**Request for Additional Information No. 346(4146) Revision 1**

**U.S. EPR Standard Design Certification**

**SRP Section: 11.05 - Process and Effluent Radiological Monitoring**

**Question 11.05-20:****OPEN ITEM****Follow-up to RAI 276, Question Q11.05-13**

**Figure 11.05-20-1—Power Dependent Variable  $\omega_{N-16}(P)$**

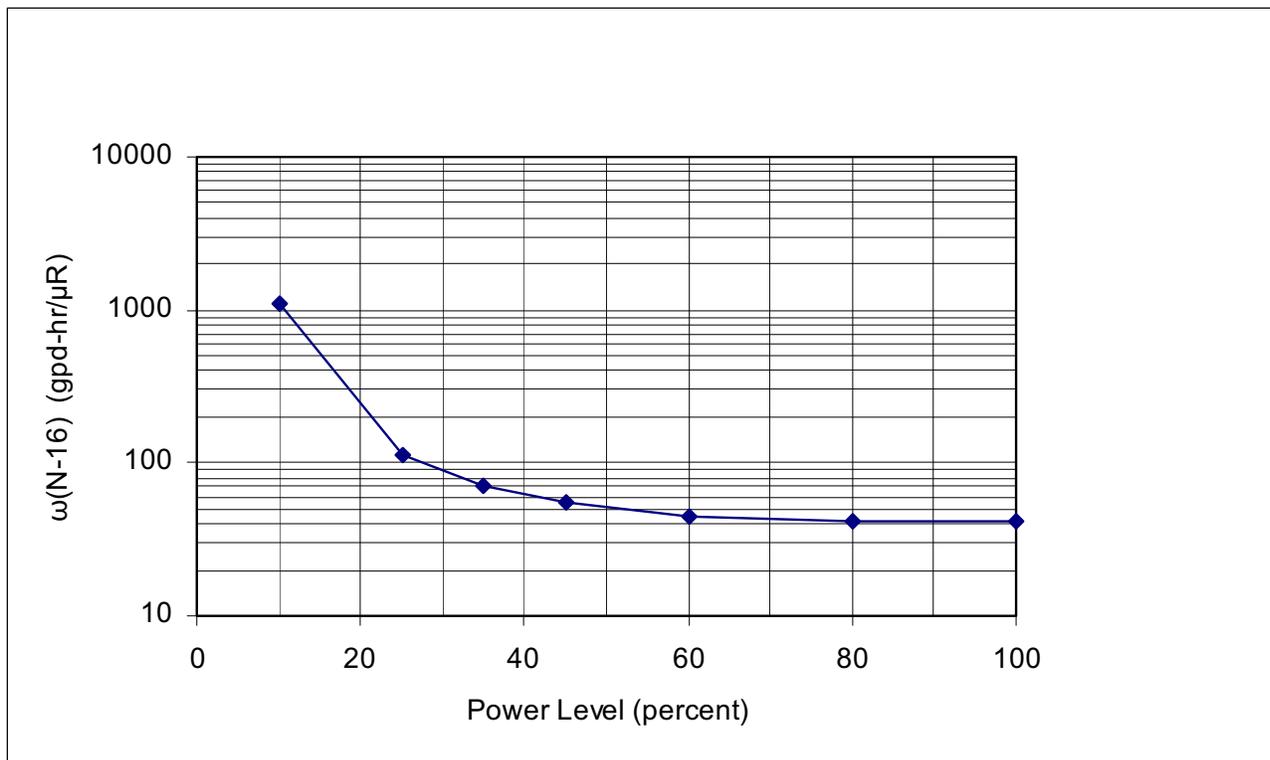
- b. In FSAR Section 11.5.2 and/or 5.2.5.3.2, describe the methodology to demonstrate that the SG blowdown radiation monitors will be capable of satisfying the technical basis of the primary to secondary leakage rate of 150 gallons per day using realistic RCS radioactive concentrations for COL applicants to comply with the requirements of EPR TS 16.3.4.12.d.

For the U.S. EPR design, variation of the correlation factor  $\omega_{\text{N-16}}(P)$  with power is shown in Table 11.05-20-1 and Figure 11.05-20-1. The listed values for this correlation factor can be used for two purposes:

- (a) To define the adjustment factor  $\delta$  using actual measurements for the leakage rate (based on laboratory analysis of SG blowdown activity) and the corresponding actual monitor reading.
- (b) For real-time tracking of the leakage rate when using the equation above.

$$\delta = L_m' / (\omega_{\text{N-16}}(P_m) M_m)$$

and  $\omega_{\text{N-16}}(P_m)$  is extracted from Table 11.05-20-1 or Figure 11.05-20-1, at  $P_m$ .
